MONOLITH HYDROGEOLOGIC ANALYSIS REPORT

Addendum

Monolith Materials
Hallam, Nebraska

Olsson, Inc.
Lincoln, Nebraska

Figure 1 The difference in simulated water levels at well G-073007 (Hallam municipal well) when hydraulic conductivity in Layers 1 and 3 are reduced by a factor of 10.

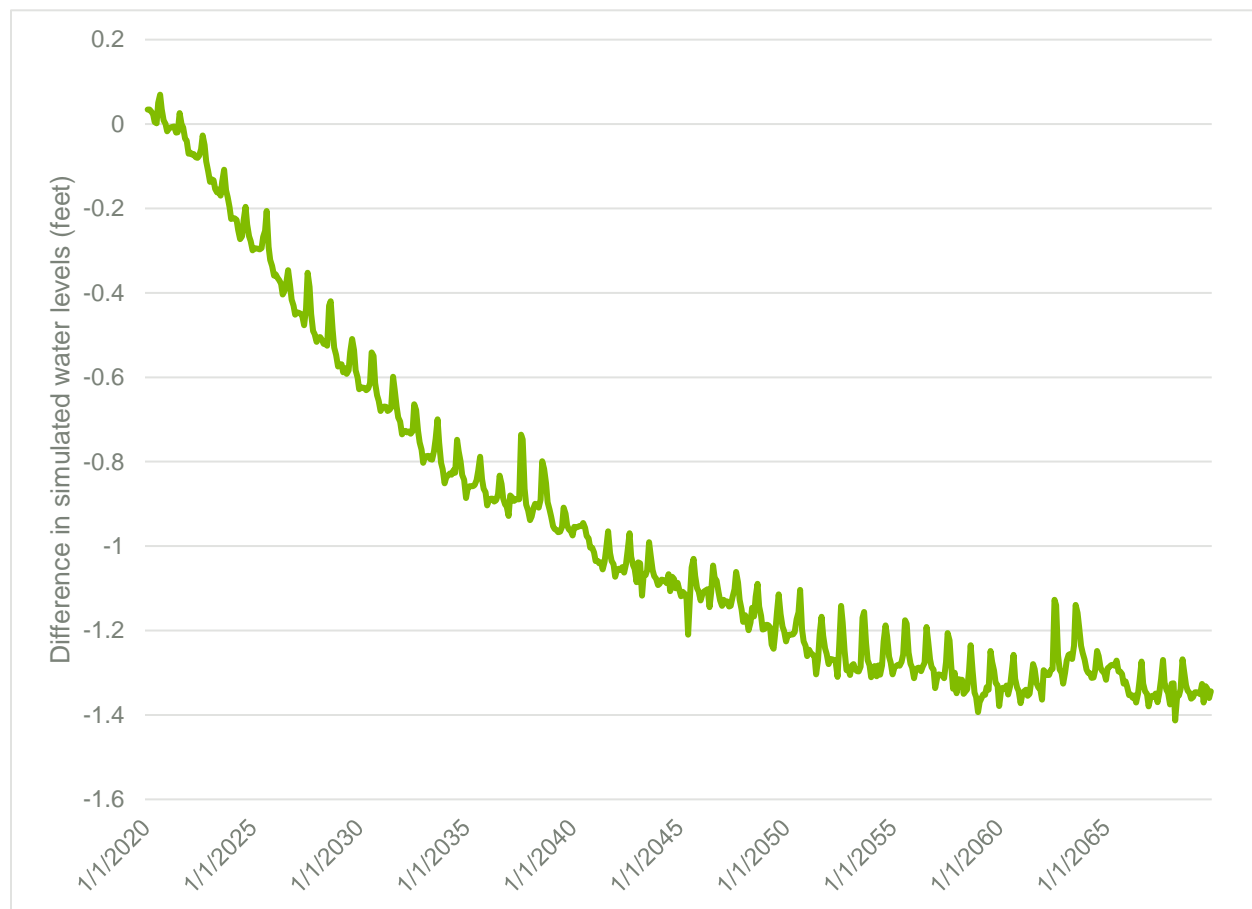
2.1 **Recommendation 1: Complete a more detailed sensitivity analysis on the following:**

- a) scale of the hydraulic conductivity in model layers 1 and 3;**
- b) horizontal/vertical hydraulic conductivity ratio in all layers.**

3.1 Motion 1: The Monolith Application submit a more detailed sensitivity analysis as recommended in LRE Water Review Recommendation 1.

From the standpoint of the impact of groundwater use in the CPA aquifer, the important question regarding the hydraulic conductivity in layers 1 and 3 is whether the assumed values in the groundwater model are too high, and if assumed values were decreased, what impact would

that have on modeled water levels in the CPA aquifer. To answer this question, the future model simulation (the baseline future model scenario with the addition of Monolith pumping) was rerun with hydraulic conductivity values for layers 1 and 3 reduced by an order of magnitude to assess model sensitivity to changes in hydraulic conductivity of these layers. The calibrated groundwater model used values of 10 feet/day and 1 foot/day for the horizontal and vertical hydraulic conductivity, respectively. So, the new simulation was changed so that horizontal and vertical hydraulic conductivity were reduced to 1 foot per day and 0.1 feet per day, respectively. This approach allows for a comparison between the impact of the addition of the Monolith water use to this reduction in hydraulic conductivity in Layers 1 and 3 (see Figure 1).

The difference starts at zero because the starting heads for each simulation are the same, then it very slowly (over the first 25 years) increases to about one foot before stabilizing at around 1.25 feet. In other words, when this difference is compared to the predicted impact at this well due to the addition of the Monolith water use (which is approximately three feet, see Report Figure 4.5) its magnitude is only half despite the dramatic decrease in hydraulic conductivity for layers 1 and 3 in the model. This demonstrates the fact that simulated water levels in for the

CPA aquifer in the Monolith groundwater model are very insensitive to the specified hydraulic conductivity in Layers 1 and 3.

Figure 2 Water level in well G-073007 (Hallam municipal well) over the 50-year Future Model simulation.

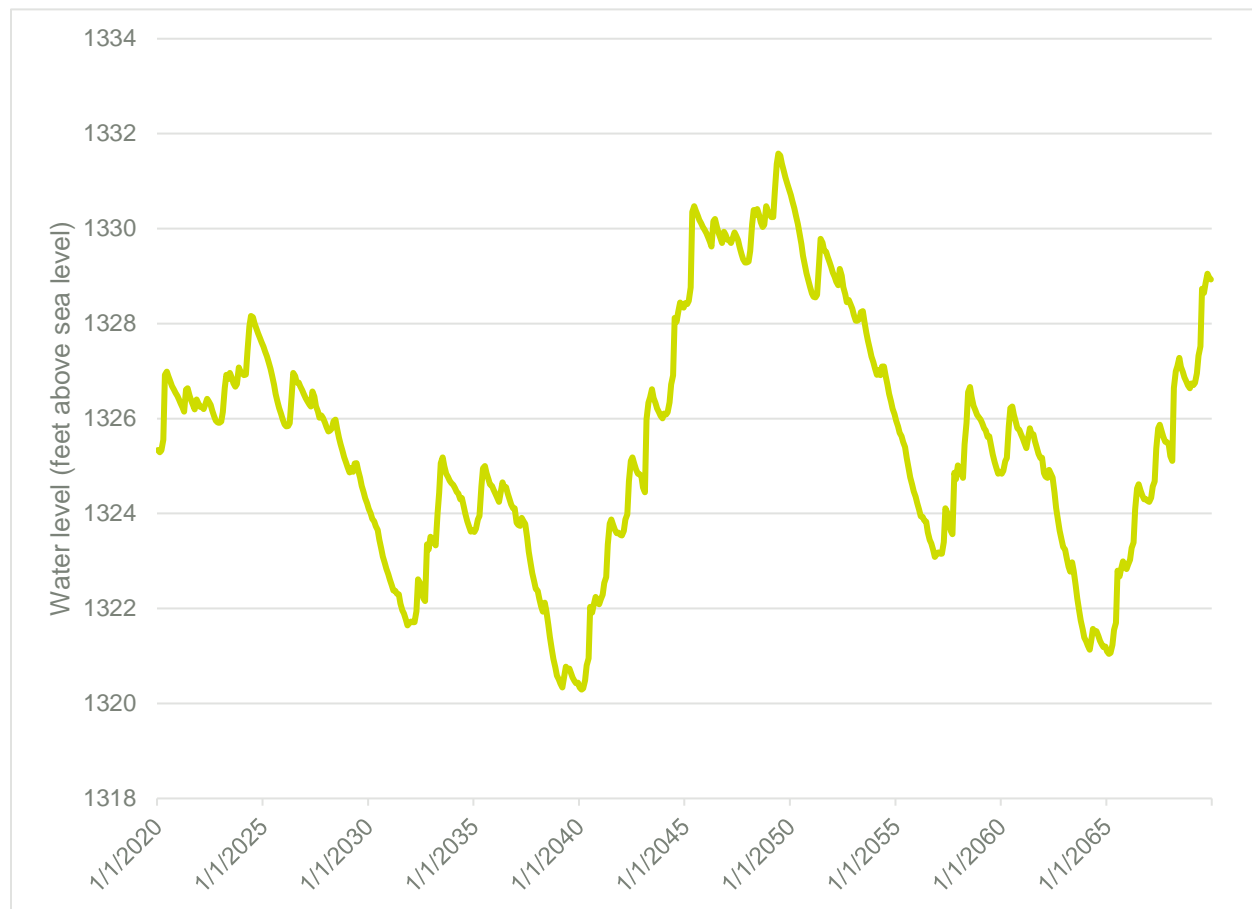
3.5 Motion 5: That Monolith provide additional information on (1) the use of future climate in the Monolith Hydrogeologic Analysis, and (2) the general effect of future climate on the CPA aquifer.

As for the general effect of future climate on the CPA aquifer, water levels are likely to fluctuate somewhat based on the occurrence of wet and dry periods. See for example Figure 2, which is a plot of the predicted water levels in well G-073007 (one of the water supply wells for the Village of Hallam). The 25-year climate pattern has periods of water level increases and

decreases, with the water level ending up being about three feet higher after 50 years. Moreover, the dips in water levels representing the dry periods are more than made up for by subsequent wet periods, so that during the second two periods of drought (occurring around 2057 and 2065), water levels bottom out at levels that are higher than the low water levels experienced during the first two periods of drought (occurring around 2032 and 2040). While not shown on Figure 2, these first two low water levels simulated in the Future Model are greater than the water level lows experienced during the actual years these droughts represent (around 2004 and 2012).

The reason for the general upward trend in water levels in the historic and future models is the general upward trend in precipitation being experienced in eastern Nebraska and much of the northern Midwest. In fact, the six-year period between 2014 and 2019 is generally the wettest six-year period experienced in eastern Nebraska in 120 years of climatic records. This is consistent with the general predictions that come from global climate circulation models, which predict that eastern Nebraska is likely to experience greater precipitation into the future.

Recommended Monitoring Zones
Monolith OC2
Groundwater Monitoring Plan
Lancaster County, NE

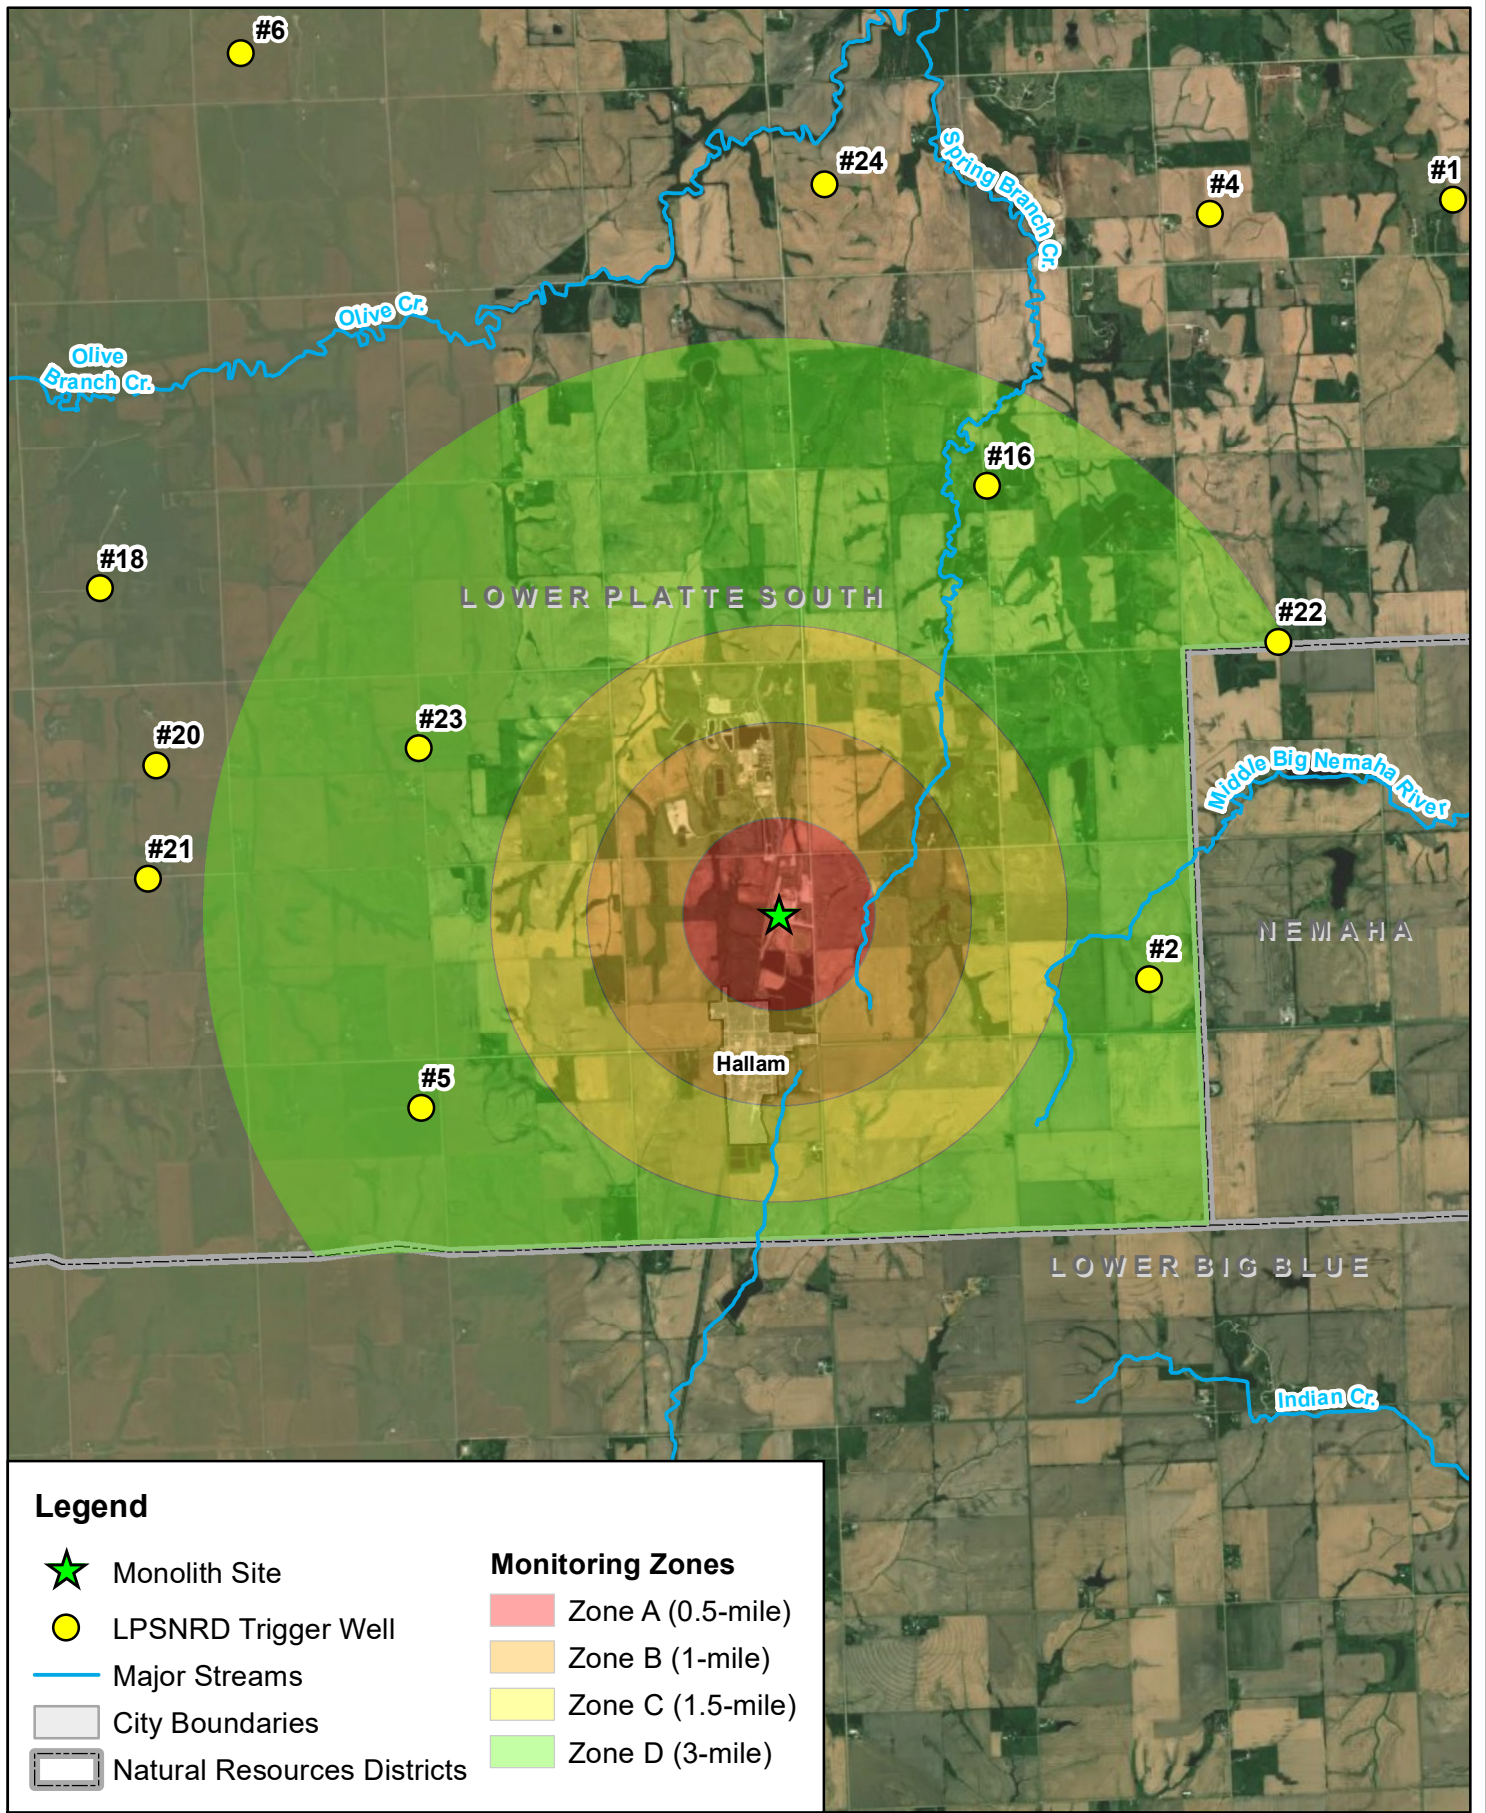
2.5 Recommendation 5: Develop a groundwater monitoring plan.

3.3 Motion 3: The Monolith Application include details of any groundwater monitoring plan Monolith intends to develop and implement to address future potential changes in groundwater quality and quantity at the Site and surround area.

The Plan area has been divided into four monitoring zones (A, B, C, and D) which form concentric rings around the Monolith site out to three miles (Figure 1). Upon review of the Plan area, it is evident that Zone D has a good distribution of monitoring locations represented by the LPSNRD's trigger wells. Additional wells would add the most value to the monitoring network if they were placed within zones A, B, and C. It is recommended that three new wells (one per zones A, B, and C) be installed to fill in the monitoring network distribution. The exact placement of these wells will depend on landowner cooperation. The new monitoring well closest to the Monolith site will be a nested well which will provide additional information on any vertical gradients that may exist or form.

Plan Area
Monolith OC2
Groundwater Protection Plan
Lancaster County, NE

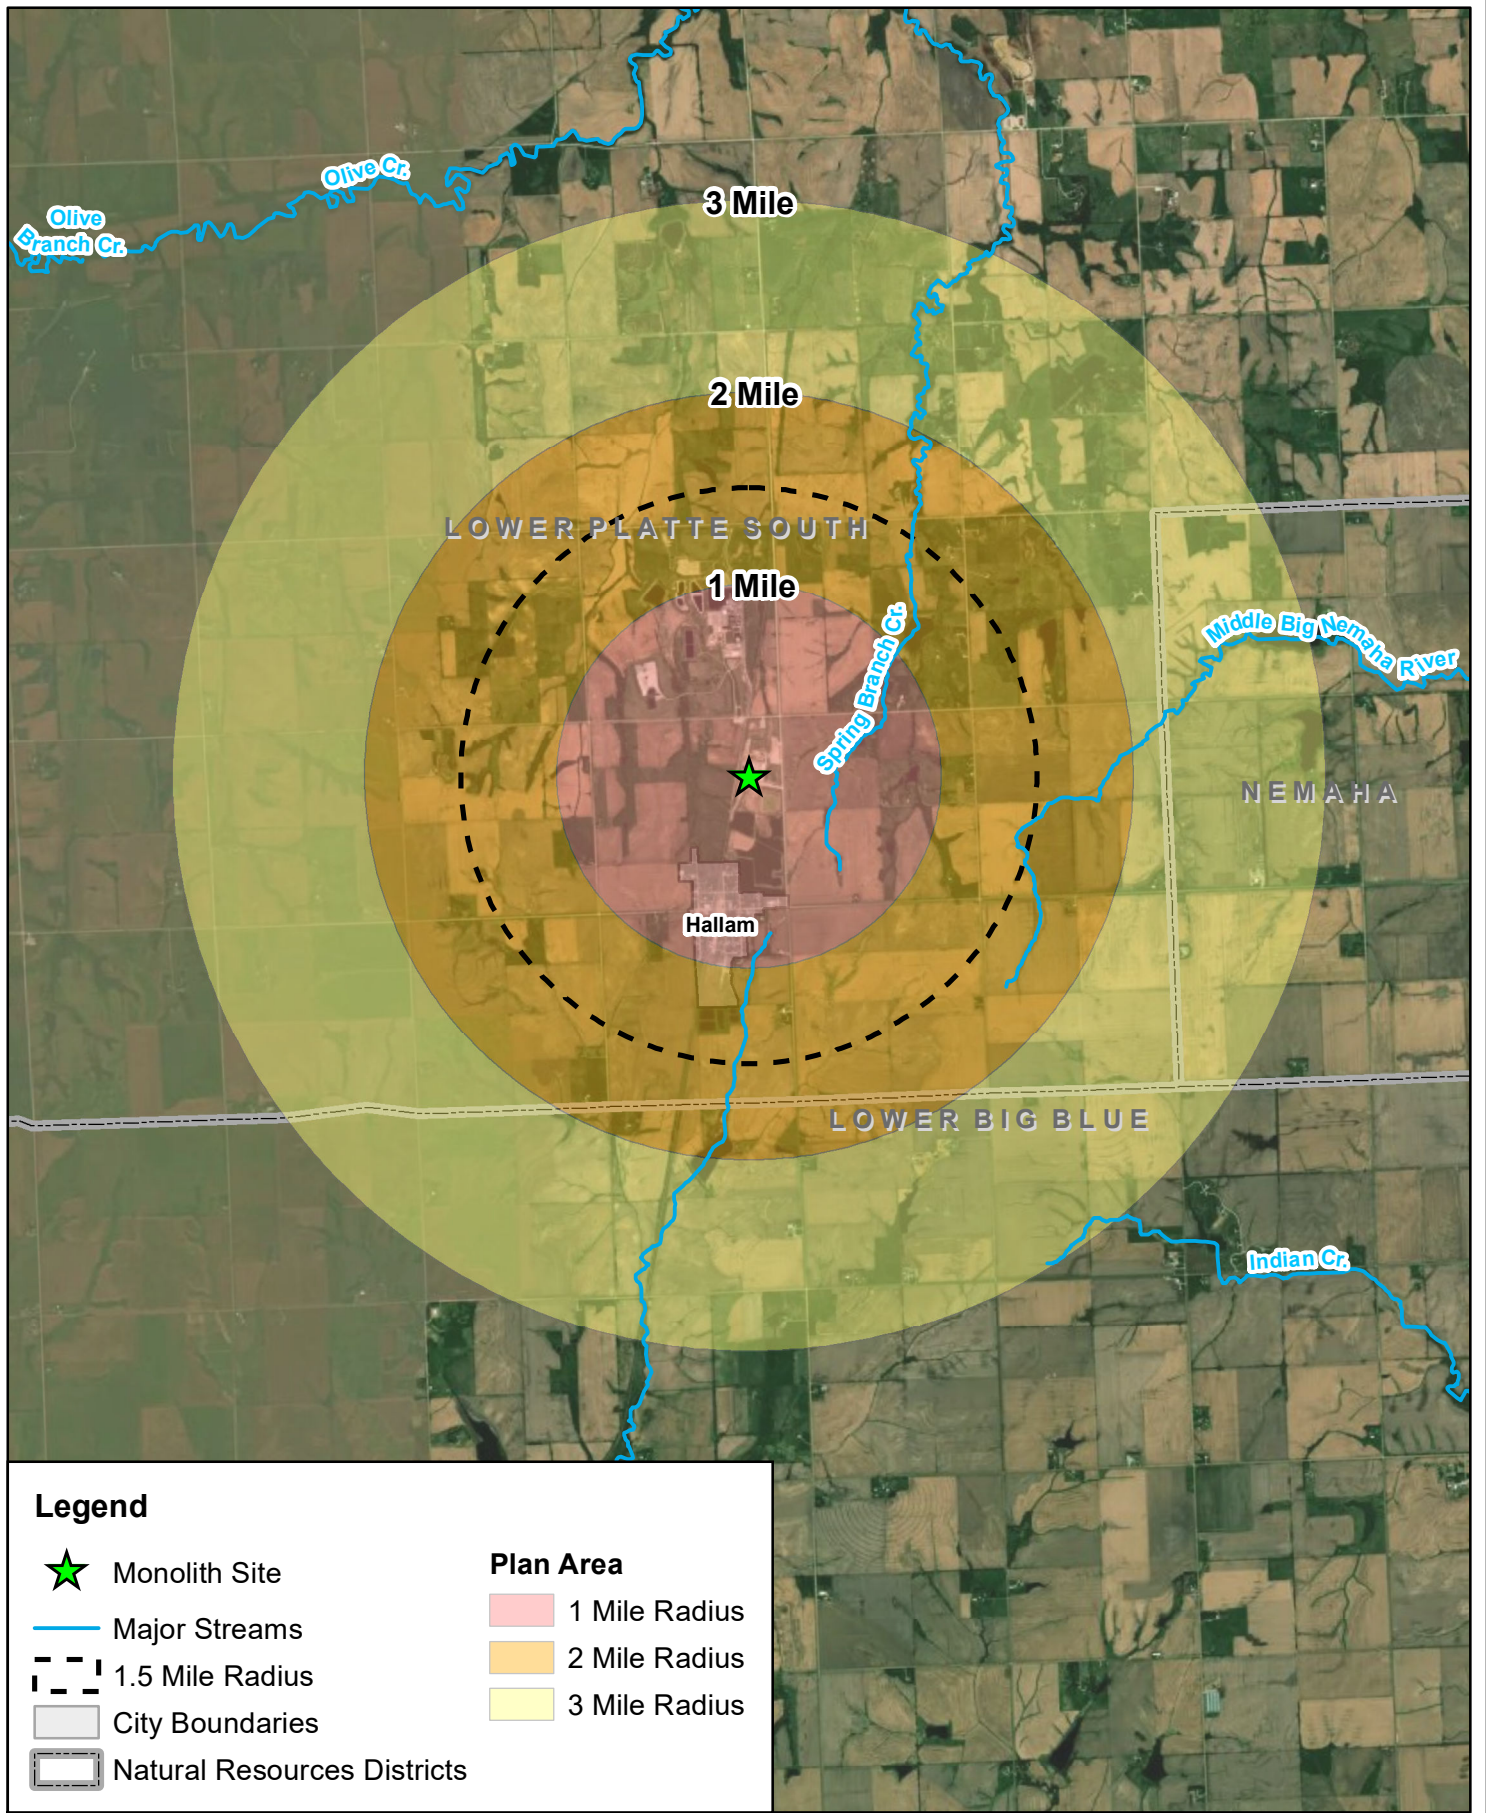
2.6 Recommendation 6: Identify and document details on all private and public supply wells within 1 ½ miles of the pumping site. Provide a well interference contingency plan.

3.4 Motion 4: The Monolith Application include details of wells and a well interference plan as provided in Recommendation 6 (the area to be considered will be increased from 1.5 miles to 3.0 miles from the site).

This Plan addresses potential well interference due to pumping at the Monolith site within a 3-mile radius (see Figure 1). Radii of 1-mile and 2-miles are shown as a spatial reference. The 1.5-mile radius represents the area originally recommended by LRE Water in their report titled *Review of the Monolith Materials Inc. Groundwater Flow Model* (LRE 2021). Upon direction from the Lower Platte South Natural Resources District (LPSNRD) Board of Directors, the Plan area was expanded to the 3-mile radius shown in Figure 1.
